Certificate of Appropriateness Application

BAR # 26-0021

1615 Keith Valley Road; TMP 41A046000 Individually Protected Property

**City of Charlottesville
Board of Architectural Review
Staff Report
May 19, 2026**

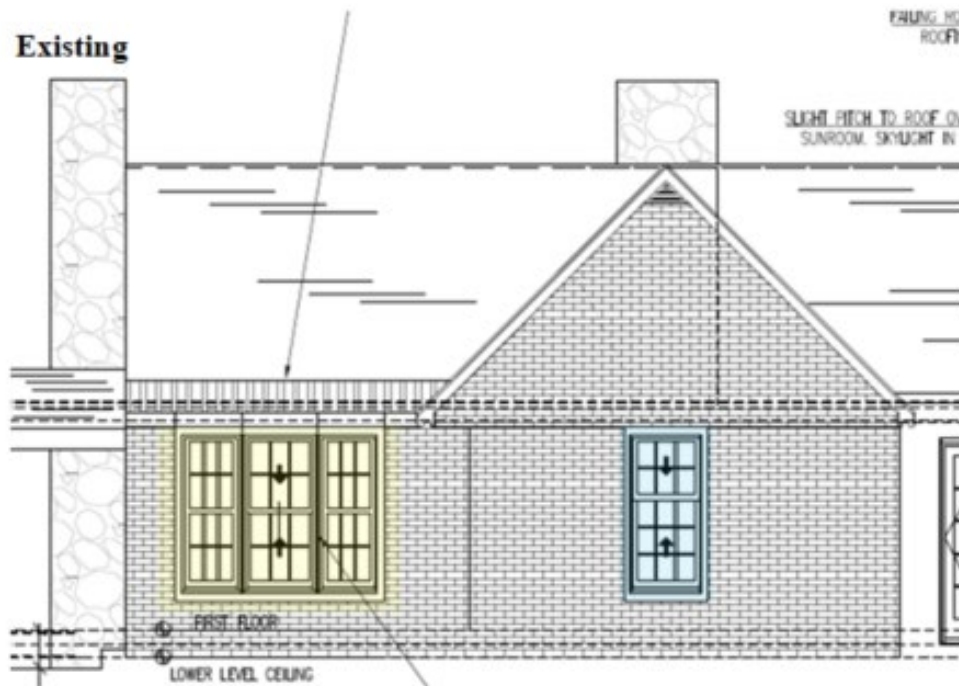
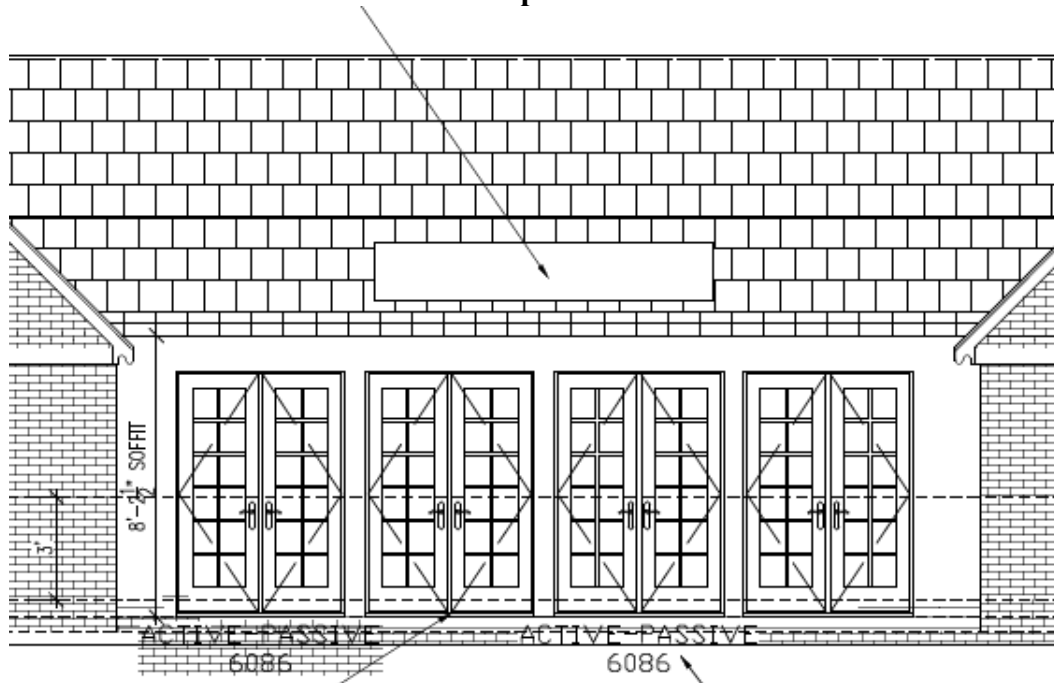
Staff recommends approval of the door and window replacements, with a condition that insulated glass will have internal spacers bars aligned with applied grilles. BAR should discuss how to address the necessary brick infill at the two windows of the north wing. Should the infilled and/or repaired sections be flush with the existing wall or recessed slightly to indicate the alterations? With the bricks whitewashed, it is not necessary to match the brick color; however, the size and coursing should correspond with the existing, and new bricks should be toothed into the existing.

Rear elevation. Corresponding with infiltration mitigation and basement foundation repair, a new window will be installed where the bay window is currently located, and a sub-grade egress window installed for code compliance. A triple-framed window will replace the single window under the north rear gable.

At the sunroom, the existing series of rear doors are to be replaced. The skylight will be replaced, and the shingle roof replaced with EPDM.

- Per the design guidelines, doors and windows with insulated glass and simulated divided lites will have internal spacer bars.
- New gutters will be half-round and downspout will be full-round.
- In addition, the BAR notes that approval of a CoA for the new garage is for the design review only and does not authorize any work requiring a building permit, nor does it supersede the City's Code of Development, which the proposed work must comply with.

PROPOSED ELEVATIONS
WITH PROPOSED GARAGE

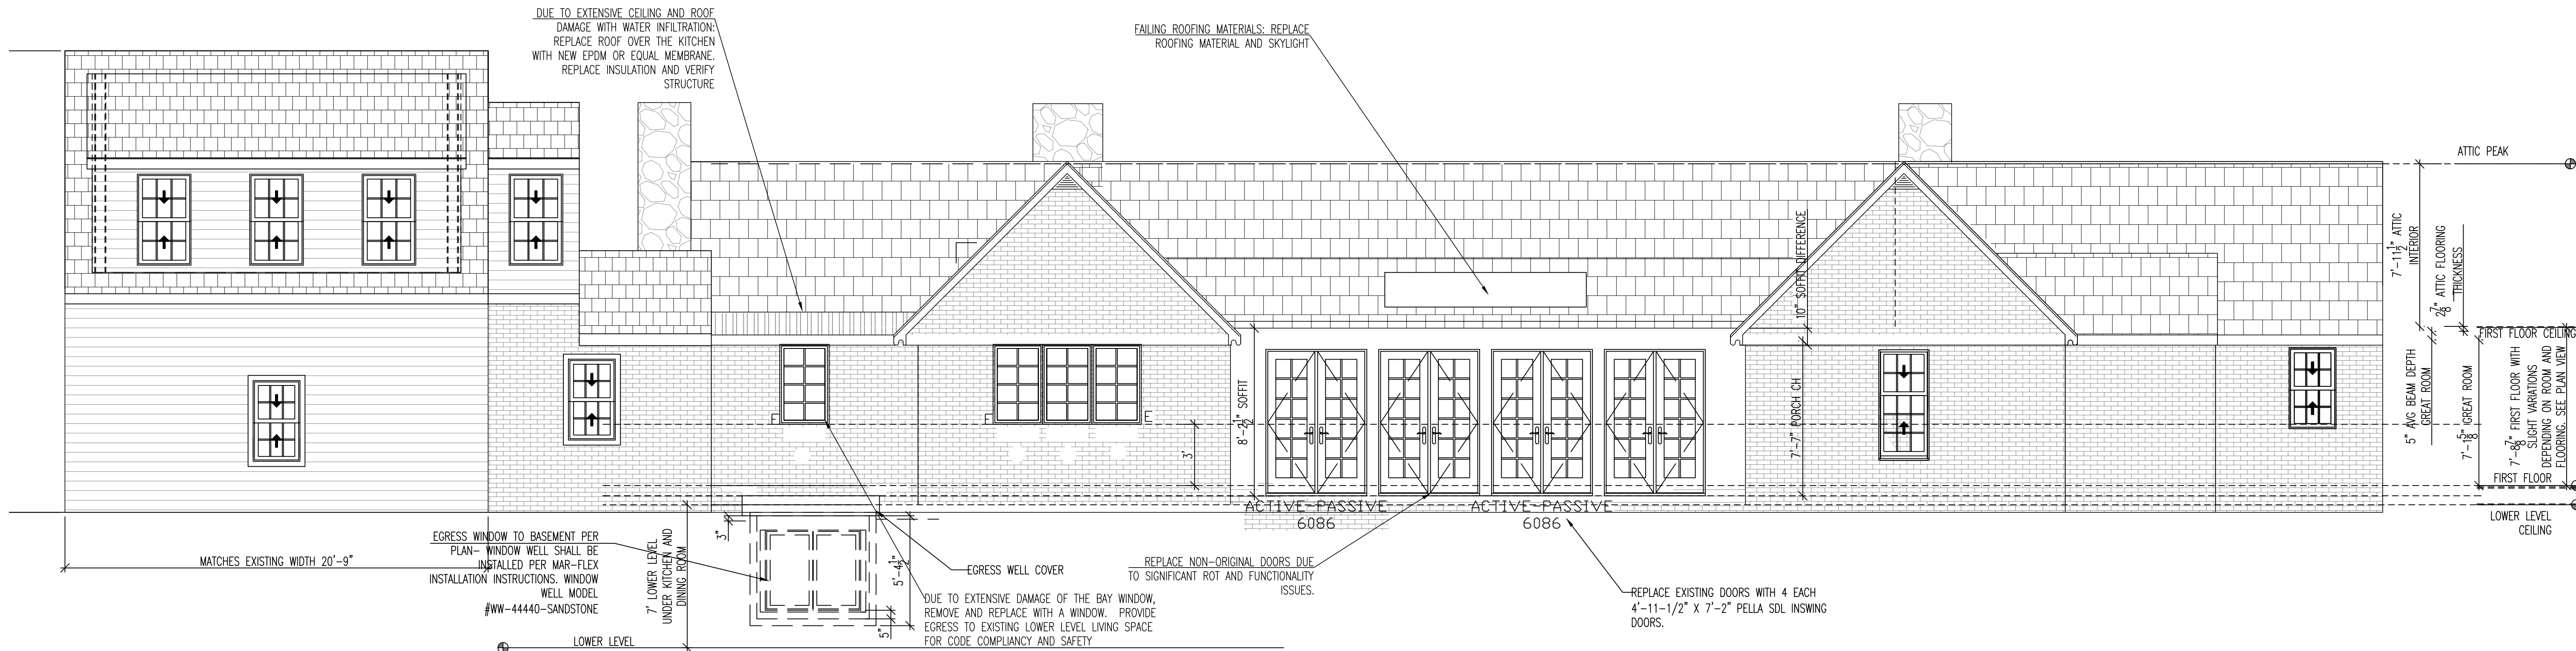
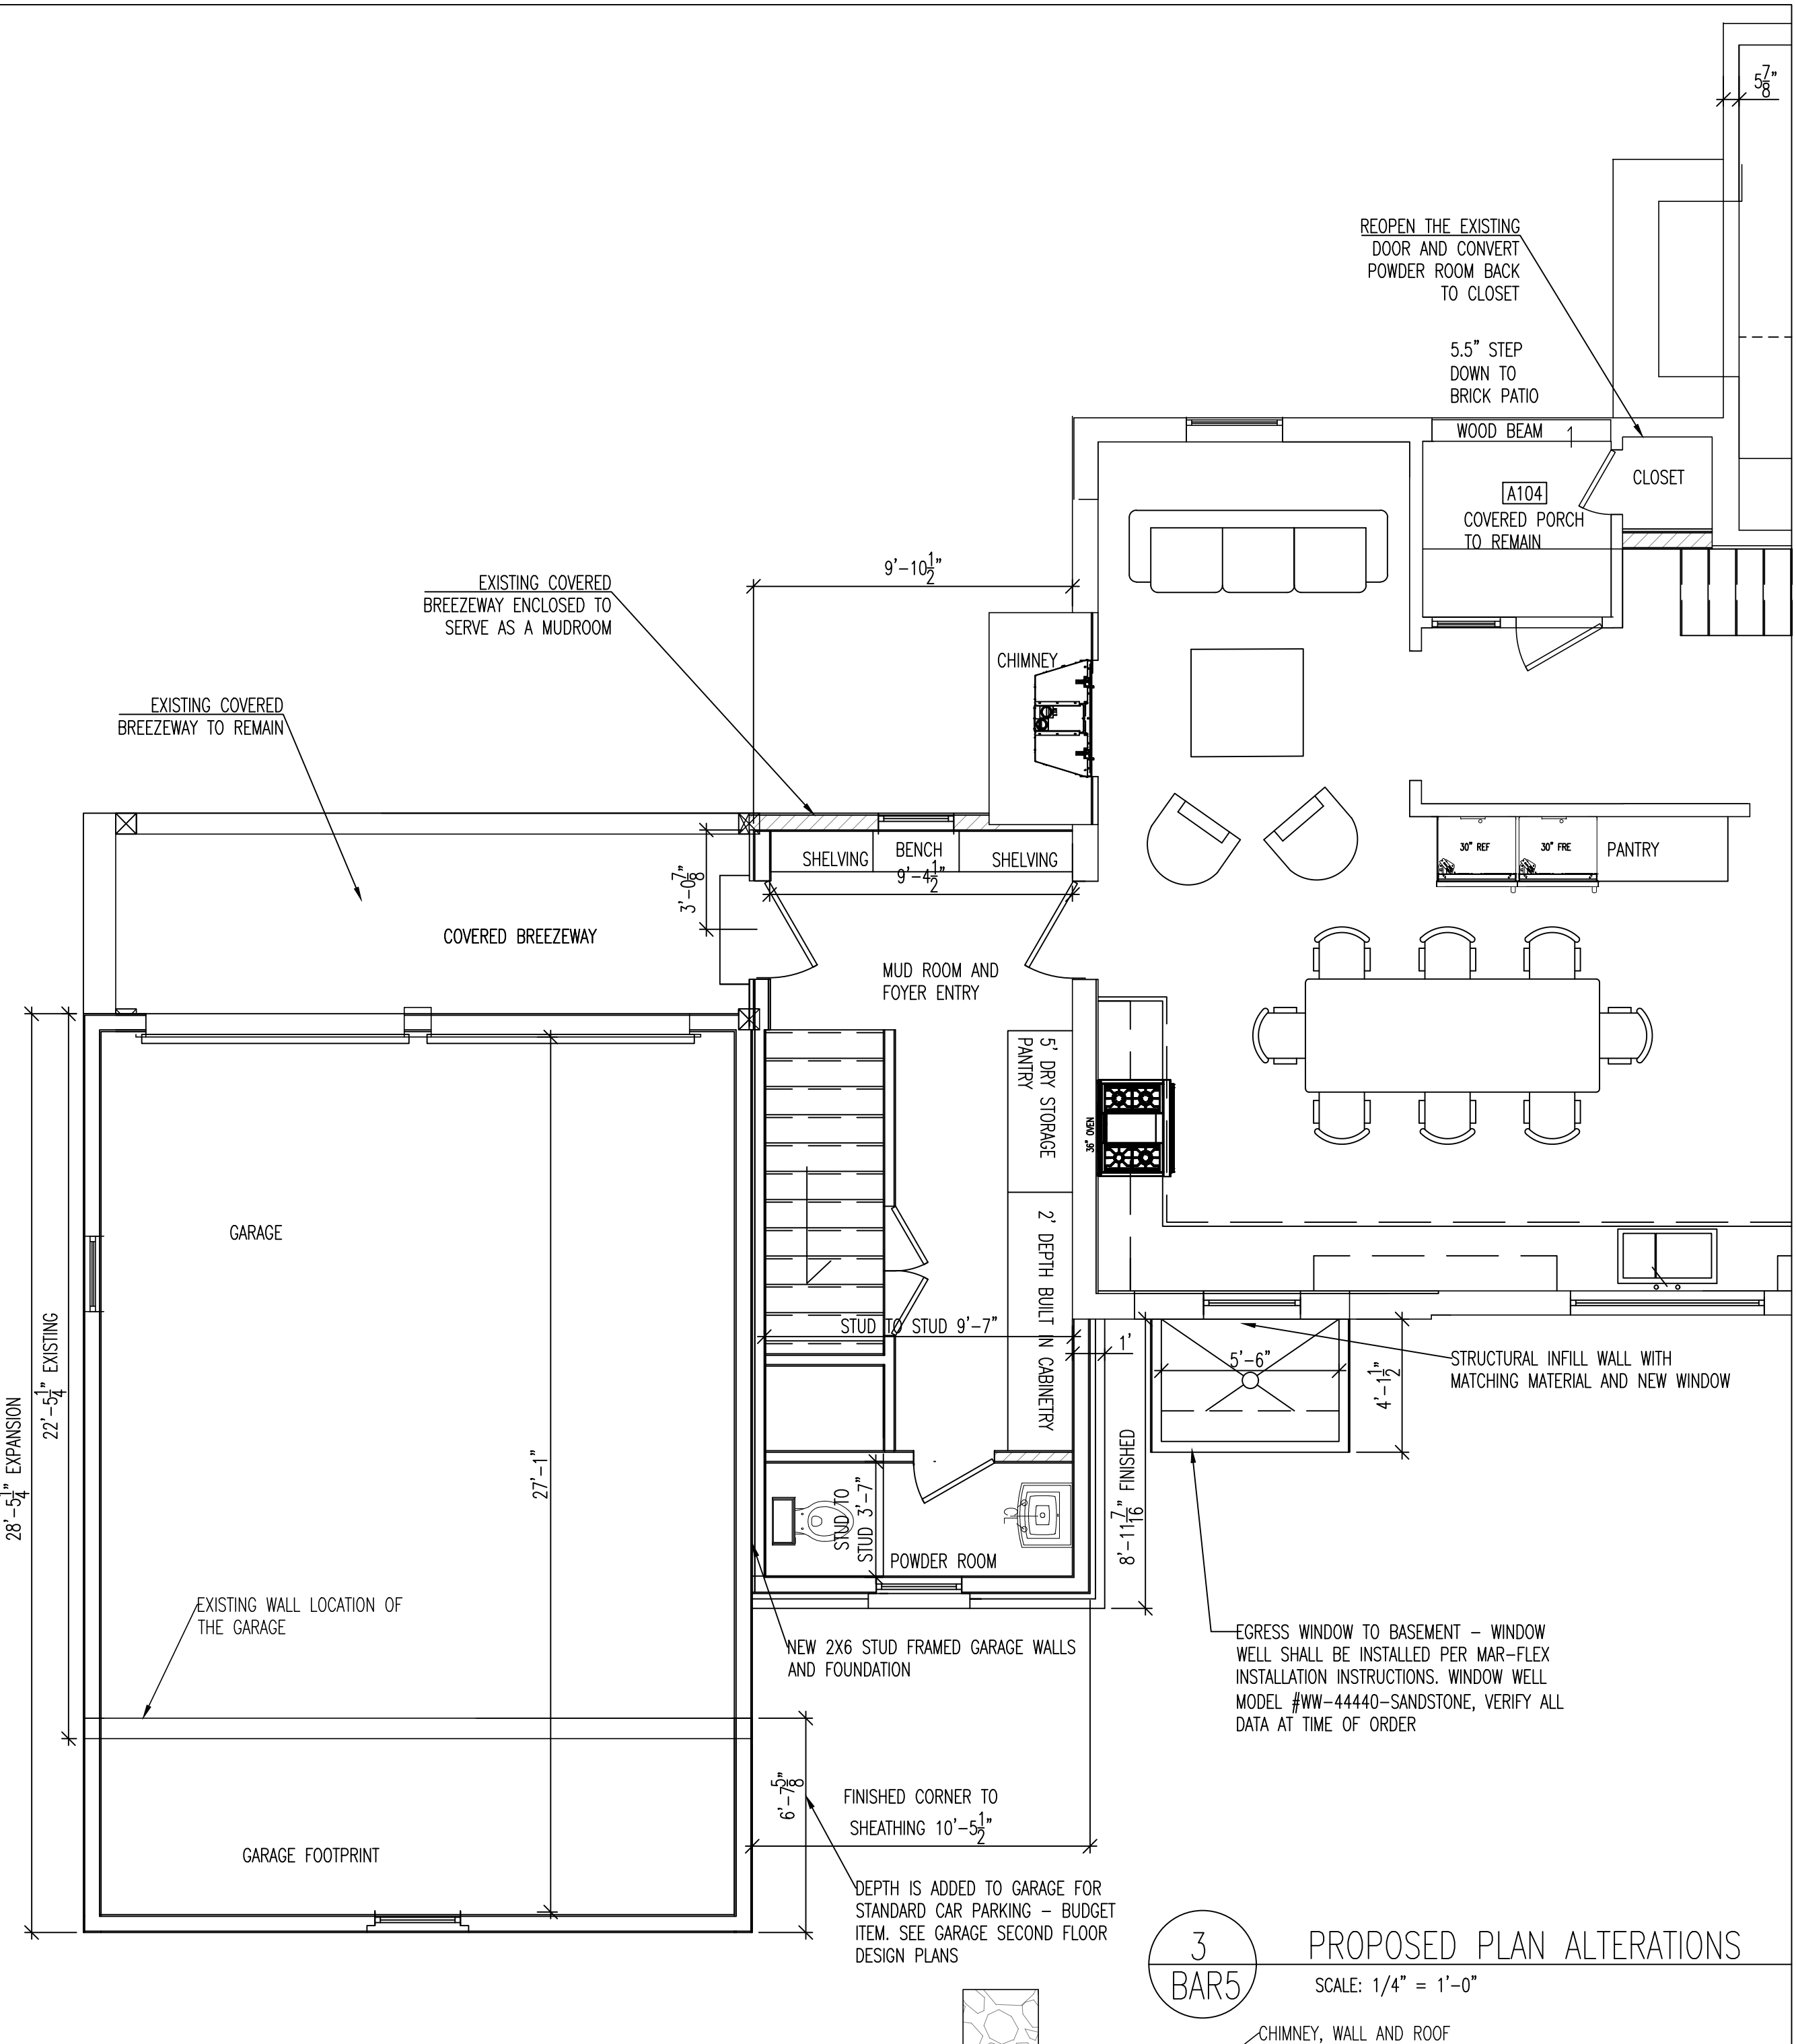
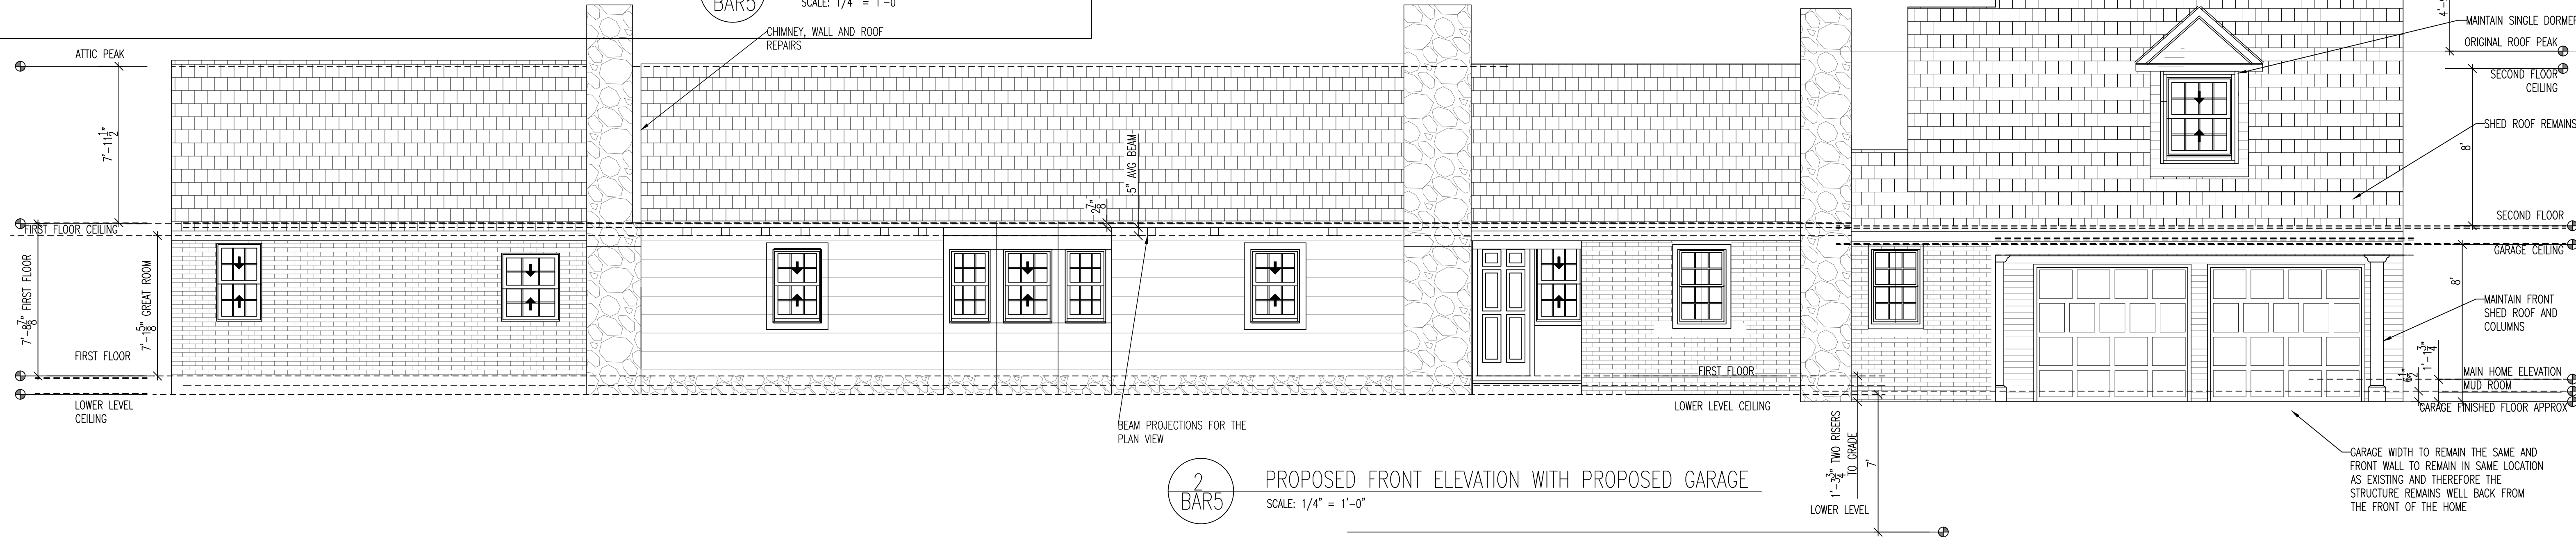
- Enclose the covered breezeway connecting the garage to the north wing of the 1937 addition. This enclosure and new construction (at the rear side) will be enclosed and enlarged, providing hall and stairway access to the second floor of the addition. Note: On the exterior walls of the connecting hall (front and rear), fiber cement board siding will be used in lieu of the brick indicated on the drawings.

Staff recommends approval of the new garage and the enclosed breezeway, with any motion for approval including the suggested comment related to the necessary zoning compliance. Note: The BAR cannot, by condition of a CoA, require, enforce or waive compliance with any requirements of
